ADDENDUM MEETING OF THE PLANNING COMMITTEE WEDNESDAY 29 NOVEMBER 2017

APPLICATION: 17/02044/F - DOCTORS SURGERY, GREYSTONE HOUSE, 99

APPLICATION: 17/01584/F, 105 - 125 ASHURST ROAD, TADWORTH, PAGE

APPLICATION: 17/01534/F - REAR OF 4 - 10 CHURCH STREET, REIGATE

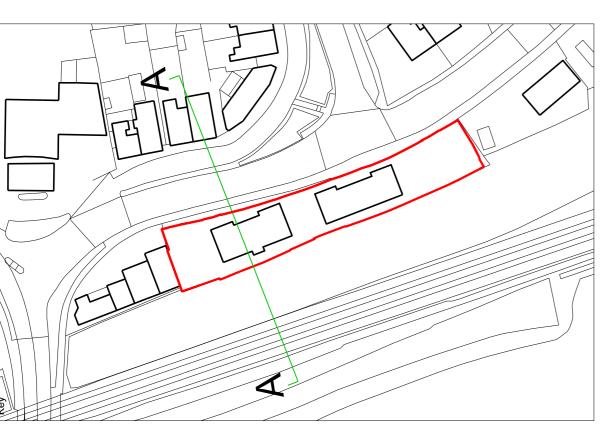
A revised OS plan has been included at **APPENDIX E** to replace the plan which is shown on page 141 of the published agenda.

The revised plan identifies the location of No.63 Woodland Way (adjacent to the application site to the west) and Langdale House (previously called Ashton House and located to the north-west of the site), both of which are referred to within the Committee Report.

Drawing Title. SITE LAYOUT

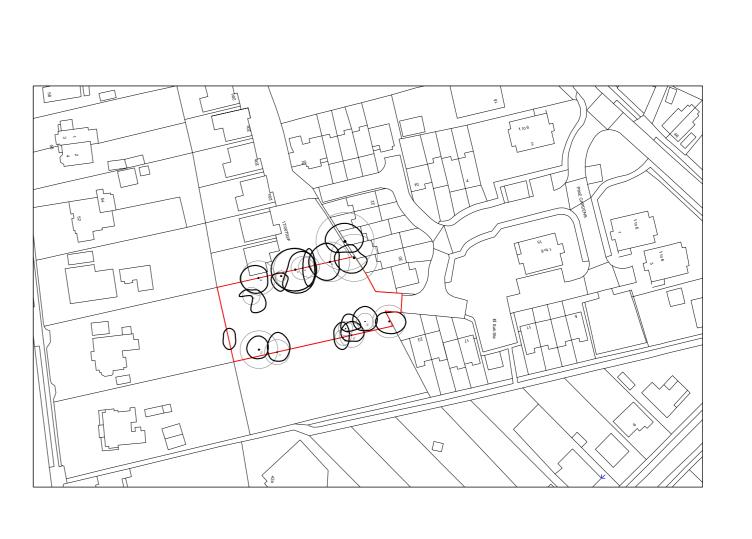
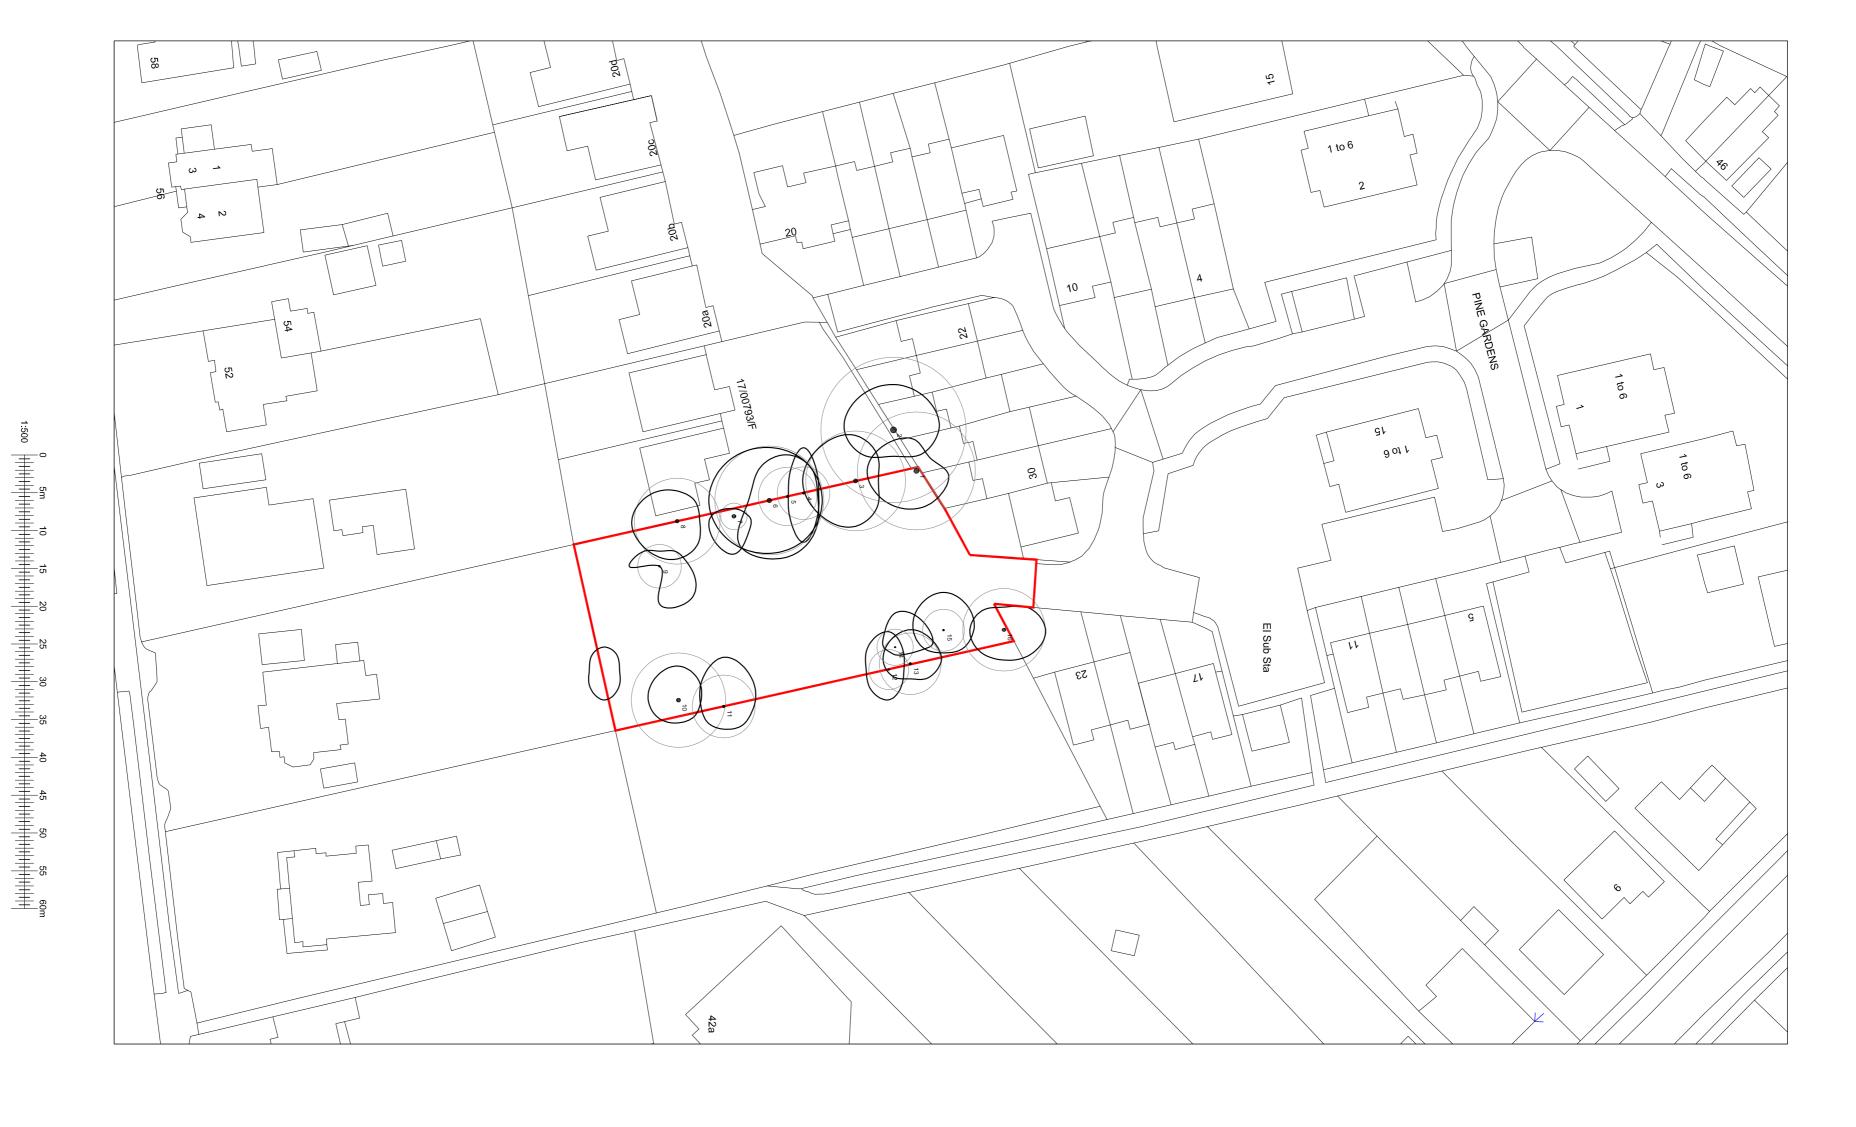
The applicant has supplied an updated existing and proposed site layout to show, by way of context, the footprint of the two dwellings approved at the last meeting of the Planning Committee on 1st November. These plans are included at **APPENDIX D.** Condition 2 has therefore been updated (below) to reflect the revised plans.

To reflect the updated plan above, condition 2 should be replaced with the following:
